WATER PERMIT NO. 6014-3

**SOUTH DAKOTA
WATER PERMIT NO. 6014-3**

REPORT ON
WATER PERMIT APPLICATION No. 6014-3
Loren Paulsen
August 18, 1997

**RECOMMENDATION OF CHIEF ENGINEER FOR WATER PERMIT
APPLICATION NO. 6014-3, Loren Paulsen**

Discharge Curve

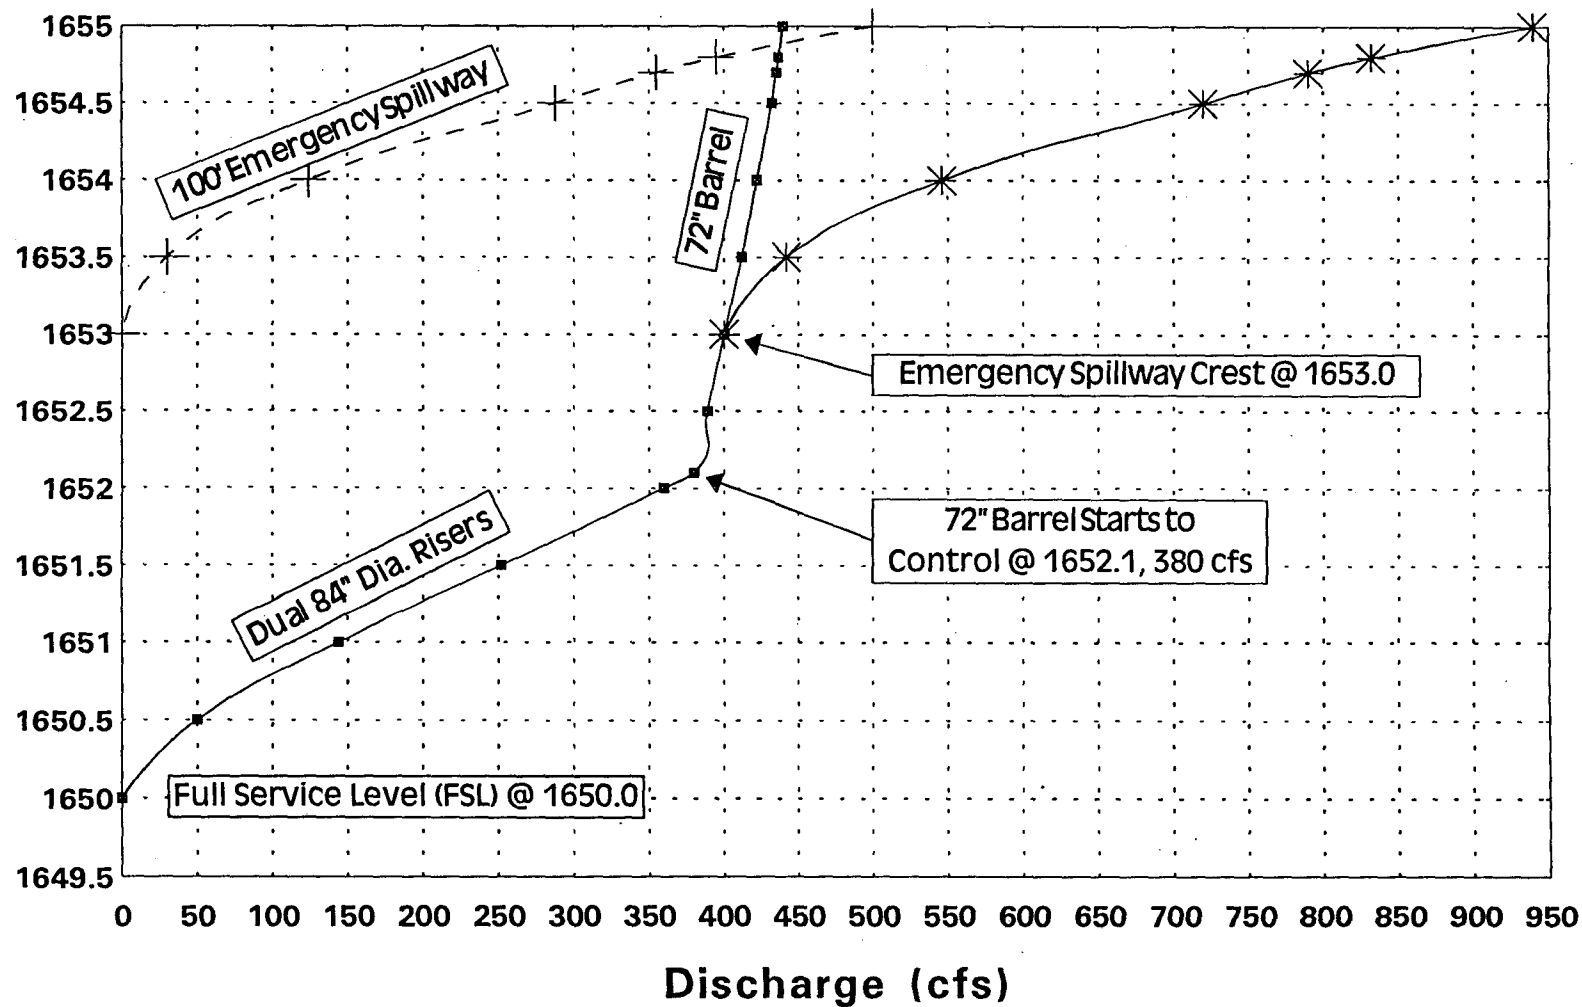
Water Permit Application No. 6014-3
Loren Paulsen

Top of Dam Elev. - 1655
2nd Spillway Elev. - 1653
P. Spillway Elev. - 1650
Emb. Toe Elev. - 1642

Emb. Height 13 ft.

Cat. 3 - Low Hazard Dam

Normal Storage Capacity - 32 Ac.-Ft.
Int. Storage Capacity - 86.4
Max. Storage Capacity - 150.9

Int. Storage Capacity x Eff Ht. = $86.4 \times 10.5 = 907 < 3000 \therefore$ Minimum
Spillway Design = 25 year frequency Event

Drainage Area - 2753 Ac = 4.30 mi.²
Slope - 3.5 ft/mile
SI - 3.33

Primary Spillway - 2-84" CMP Riser w/ 72" Barrel, Capacity = 387 cfs
2nd Spillway - 100' wide Earthen w/ 2' head, Capacity = 732 cfs

Ducks Unlimited uses the NRCS - TR20 model to route Q_{25} peak = 415 cfs thru the primary spillway with 2.58 ft of freeboard available and the Q_{100} peak = 795 cfs thru both spillways with 0.46 ft. of freeboard available.

Section 74:02:08

1. Topo Map - OK
2. Dam Axis Profile - OK
3. Dam X-sec. - OK
4. Area-Capacity - OK
5. Outlet Details - OK
6. Discharge Capacity - OK
7. Spillway Details - OK
8. Specs. - Std. - OK
9. EPP - Cat. 3 - N/A
